PRODUCT CHANGE NOTIFICATION

#PCN-IFC-B9L4-13

Business Unit	Product Line Code	Type of Change	Action	Date of issue
IFC	BF7	Mechanical	Notify Distributors and Field	11/12/2013

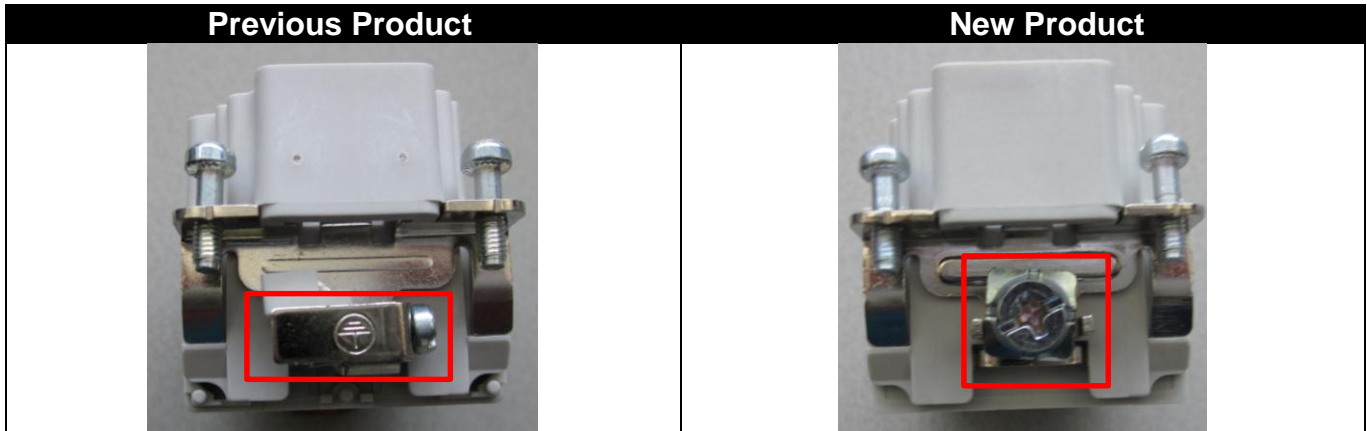
The PE-screw (grounding screw) design will be changed in order to accommodate a larger conductor cross section. The previous version allowed for a 2.5 mm² (14 AWG) max wire, where the new design accommodates up to a 4.0 mm² (12 AWG) wire.
